Environmental  
Restoration  
Contractor**ERC Team**  
**Meeting Minutes**

**SUBJECT** 100-NR-1 AND 100-NR-2 PROPOSED PLANS DRAFT B COMMENT RESOLUTION MEETING**TO** Distribution**FROM** E. T. Coenenberg *ETC***DATE** August 22, 1997**ATTENDEES**E. T. Coenenberg (ERC) H9-03  
L. E. Gadbois (EPA) B5-01  
B. Mukherjee (ERC) H0-17  
S. J. Ingle (ERC) H9-02  
D. E. Olson (RL) H9-12  
P. R. Staats (Ecology) B5-18  
M. H. Sturges (ERC) H9-01  
B. L. Vedder (ERC) H0-17**DISTRIBUTION**Attendees  
M. C. Kelly H9-01  
Document and Information Services H0-09

**SUBJECT** 100-NR-1/100-NR-2 DISCUSSION OF 15 FT POINT OF COMPLIANCE  
ISSUE AND COMMENT RESOLUTION ON PROPOSED PLANS

**SUBJECT** REVIEW OF THE REDLINE/STRIKEOUT VERSION OF THE 100-NR-1/100-NR-2 AND TSD PROPOSED PLANS

**Figure 1. DOE-RL/Ecology Interpretation of MTCA 15 Foot Depth Concept.**

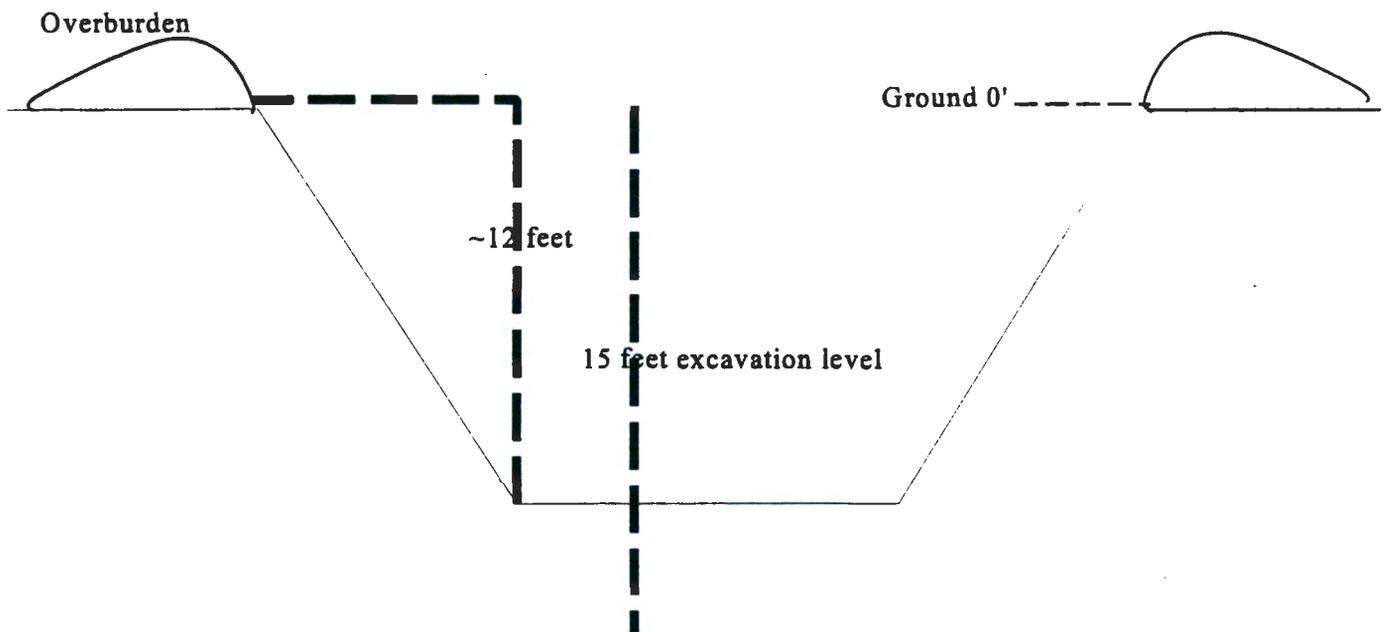
consistent with the intent of the regulation and calls for excavation of the cribs and trenches 15 feet below the surrounding grade. Figure 1 illustrates the basic configuration of a crib and indicates ground 0 and 15 feet as interpreted by RL and Ecology. RL and Ecology do not propose to take credit for overburdens which may have been added under the RARA program.

**Figure 2. EPA Interpretation of MTCA 15 Foot Depth Concept.**

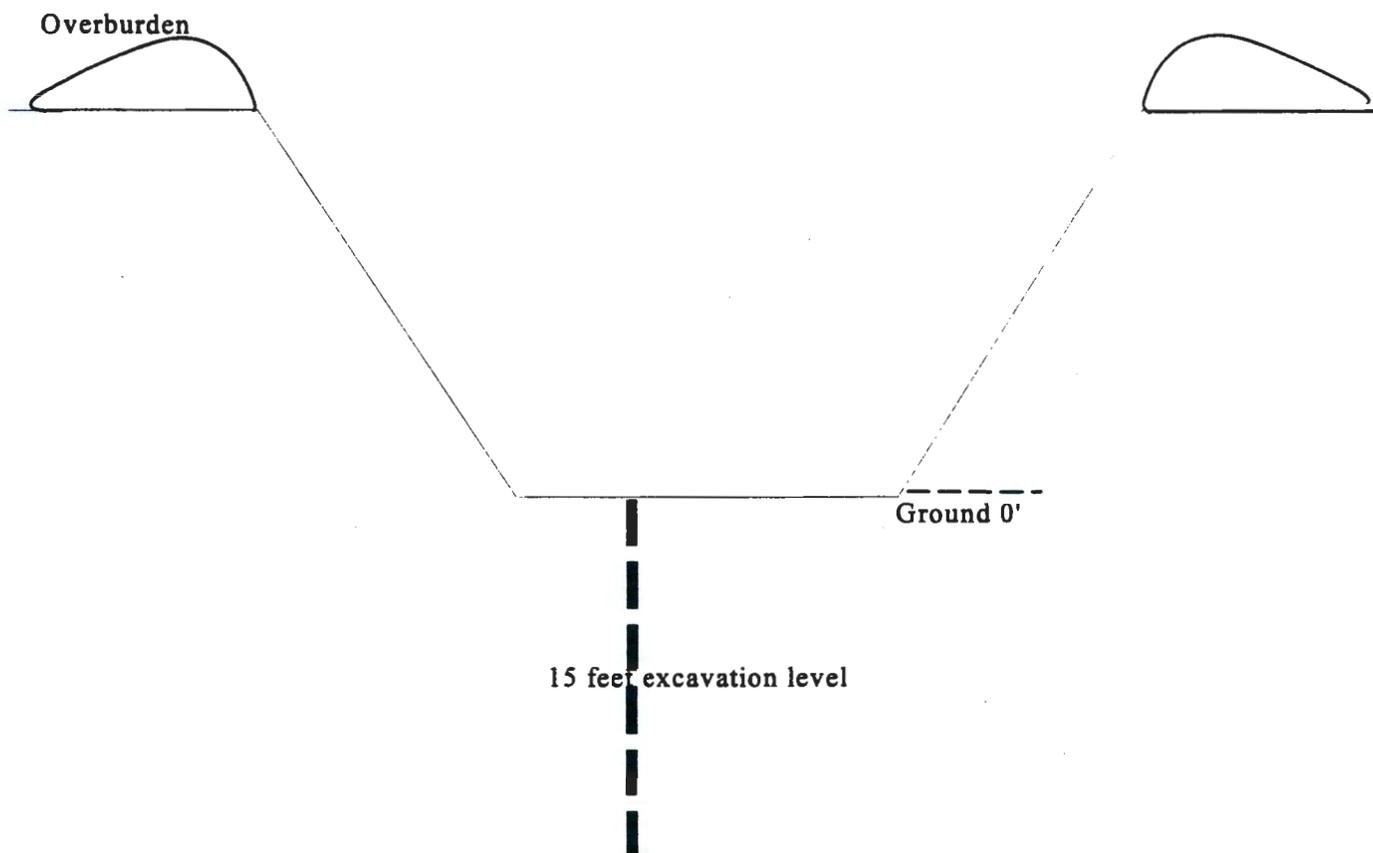
EPA, on the other hand, interprets the regulation to mean that excavation begins at the surface where discharges were made during operations of the disposal unit. In this case, ground 0 would be the bottom of the cribs and excavation would be required to 15 feet below that point. Figure 2 illustrates the excavation strategy using the EPA interpretation. It is EPA's contention that this is the interpretation that is being practiced in the 100-B/C Area at Hanford and that interpretation should be consistently applied throughout the 100 Area. It was noted, however, that there are other places within the state where the DOE/Ecology interpretation has been applied.

Figure 3. Other Potential Interpretations of MTCA 15 Foot Depth Concept.

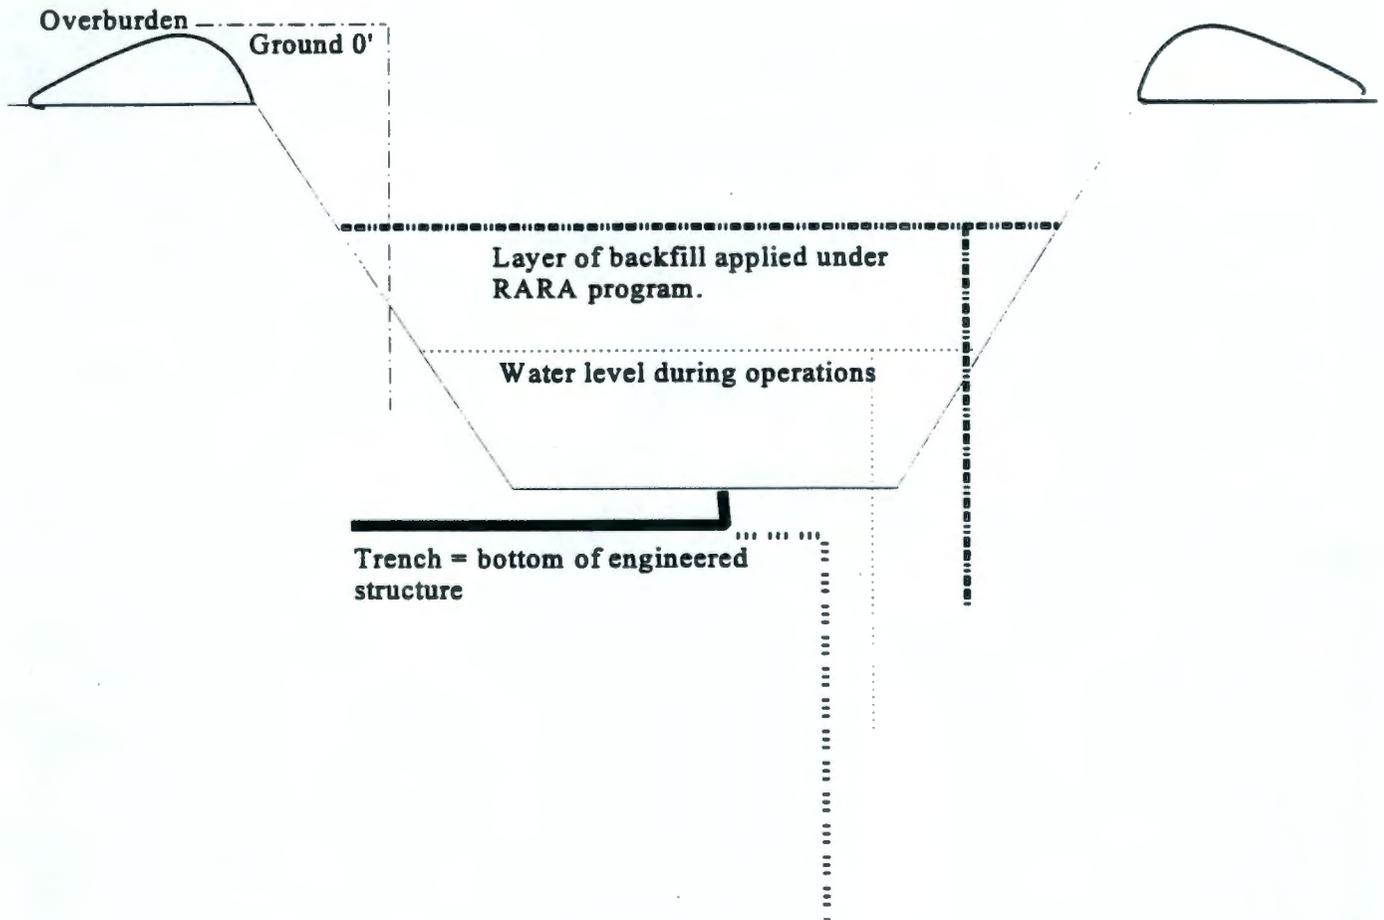
In addition to the interpretations presented by DOE/Ecology and EPA, there are variations that could also be considered for application in the 100-N Area. Figure 3 illustrates other potential interpretations.

**HANDOUTS DEPICTING ENGINEERING STRUCTURE ABOVE 15 FT,  
ENGINEERED STRUCTURE BELOW 15 FT, AND PLUMES ABOVE 15 FT**

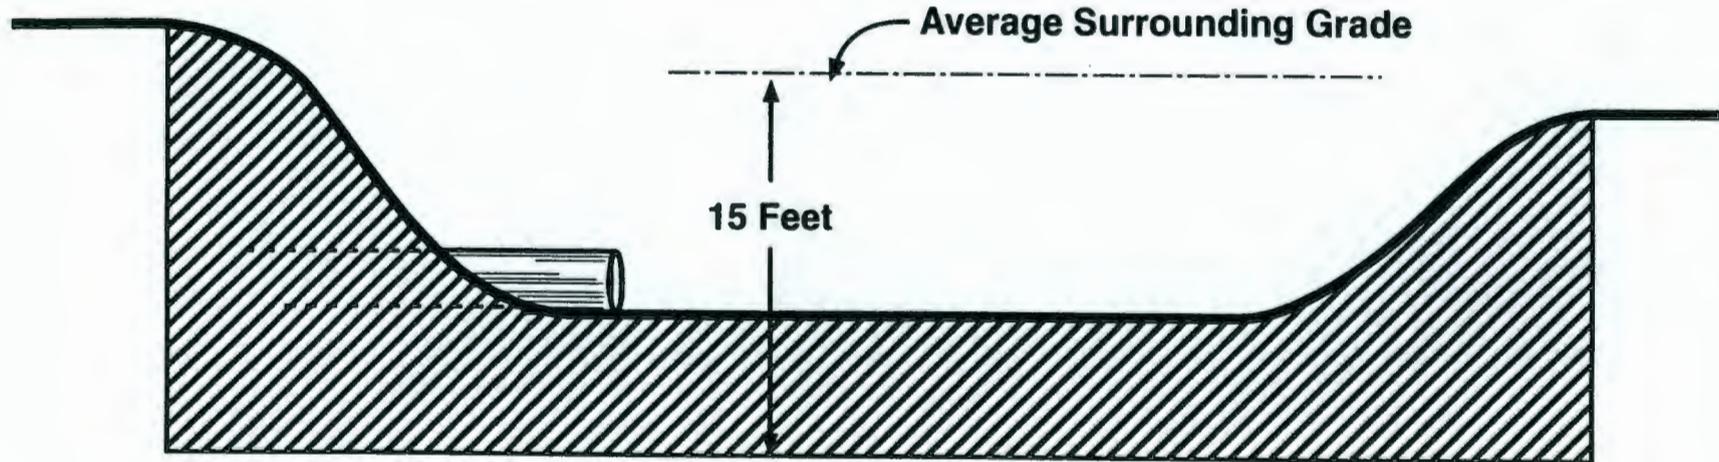
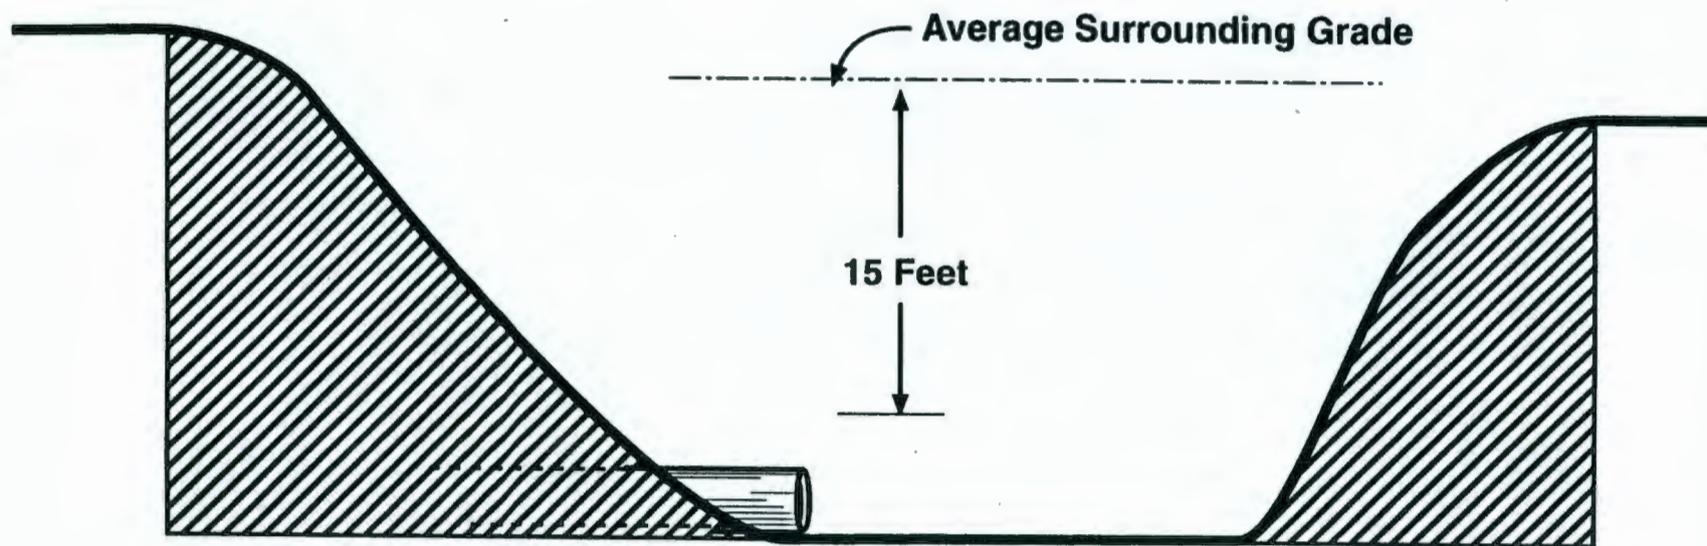
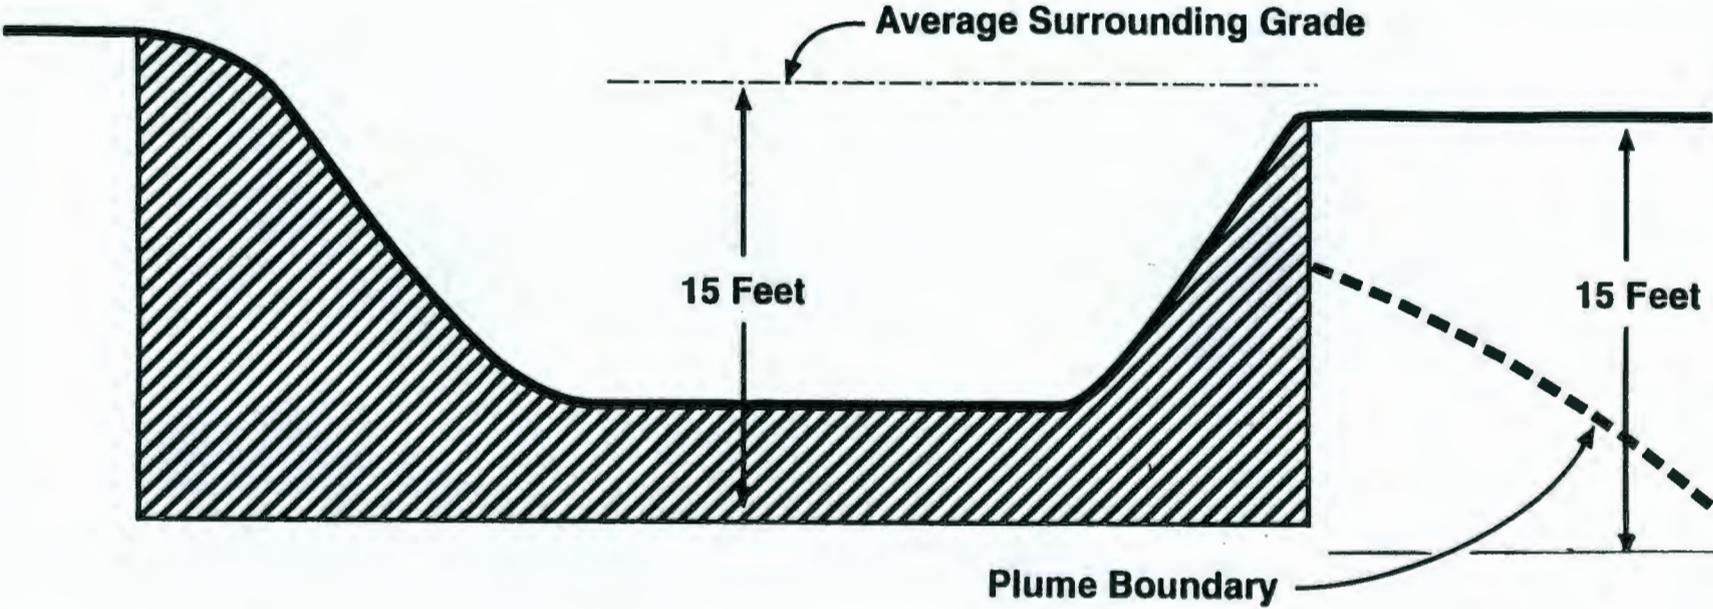
where the bottom of the engineered structure is above 15 ft, and the surrounding grade was determined using the averaging method. The typical section in the first diagram is analogous to 116-B-11. Reference drawings 0100B-DD-C007, Rev. 0 and 0100B-DD-C015, Rev. 0 for 116-B-11 Civil Plot Plan and Civil Sections and Details were reviewed to illustrate this typical section.

The third diagram is analogous to any site with shallow zone plumes, and shows a contamination plume beyond the area of expected contamination. In this case, where the plume is "chased" beyond the planned excavation, the average surrounding grade is not used as the reference grade, but rather the overlying ground surface elevation is used instead.

Figure 4-3. Remediation Zone Cross-Section for 116-N-1 and 116-N-3.

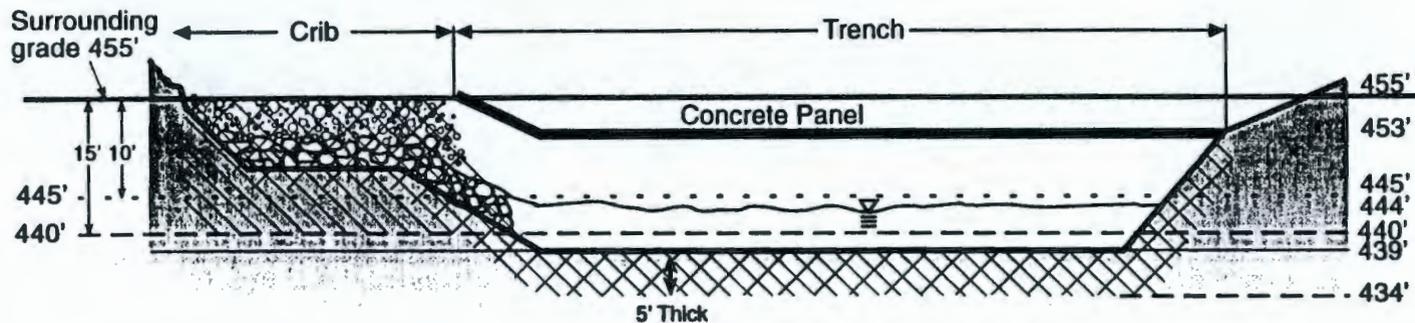
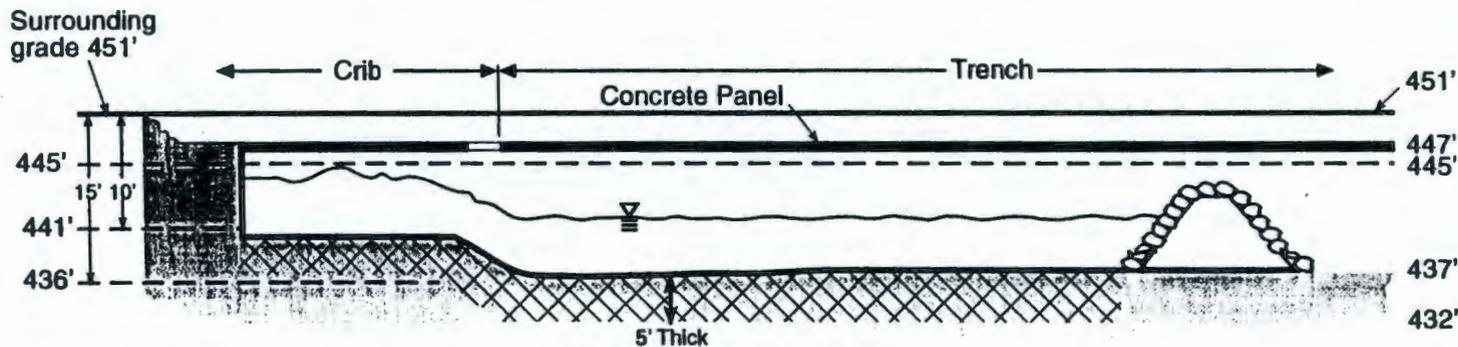
It is noted that the drawings in the Corrective Measures Study pertaining to 1301-N and 1325-N will be revised.

The final minutes from the August 7, 1997, and August 13, 1997, meetings were signed by EPA. Ecology, RL, and BHI. It was noted that the diagram showing the cross sections of the 1301-N and 1325-N Cribs and Trenches attached to the August 13, 1997, minutes had the 436 elevation incorrectly placed. Ms. Coenberg took the action to correct the location of the 436 elevation on the diagram. After the diagram is corrected the minutes will be issued. The draft August 18, 1997, meeting minutes were distributed for review, and it was agreed to send the electronic file of the minutes to all reviewers. The meeting minutes will be signed once they are finalized, pending comments from the attendees. The discussion then focussed on whether these meeting minutes should be placed in the AR. It was agreed that the minutes and the EPA comment resolution package should be entered into the AR. However, it was noted that the request to enter these items into the AR would need to come from Mr. Staats, who agreed to formalize the request.

**Figure S-3. Environmental Cleanup Strategy.**

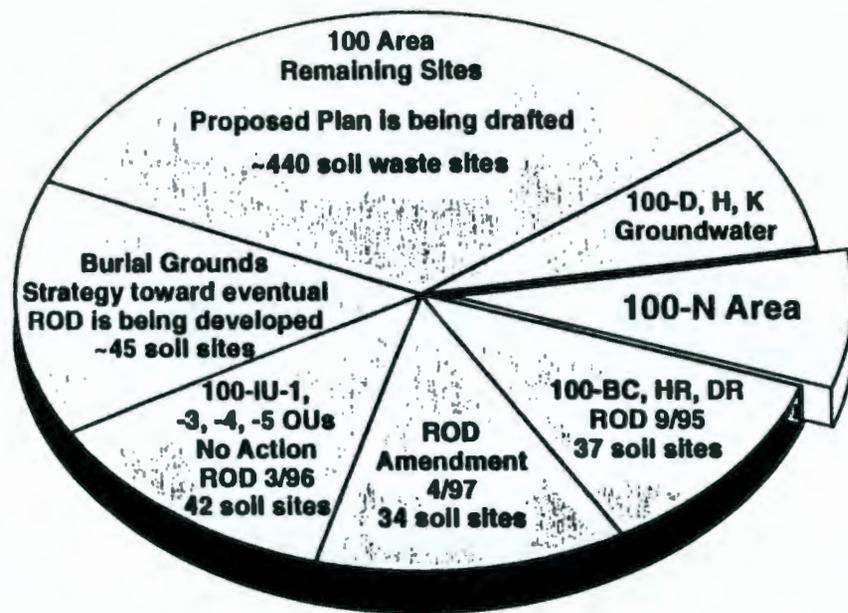
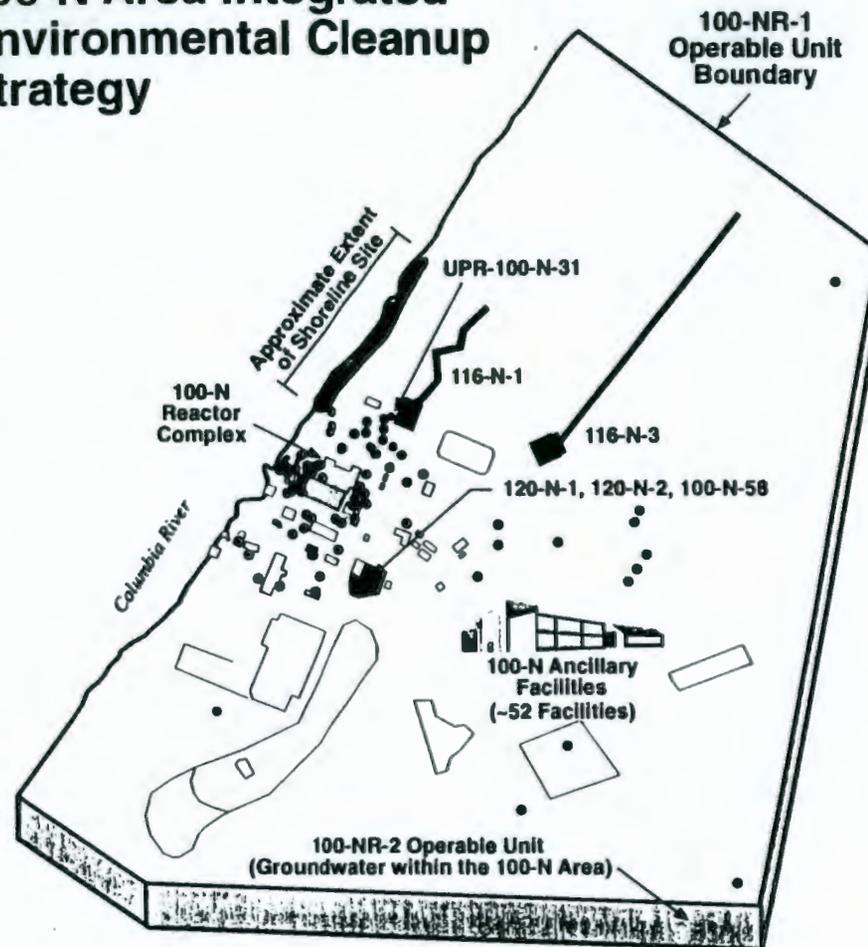
Mr. Gadbois had no specific comments on the graphic entitled Overview of Waste Site Cleanup Process and Associated Documents. On the color graphic depicting the environmental cleanup strategies in the 100 Area and the 100-N Area, Mr. Gadbois suggested deleting the following information about the 100 Area Remaining Sites Project: ~350 solid waste sites, +~90 100-IU-2 and-6 soil sites, and changing to ~440 soil sites. This comment was accepted and has been incorporated into the graphic.
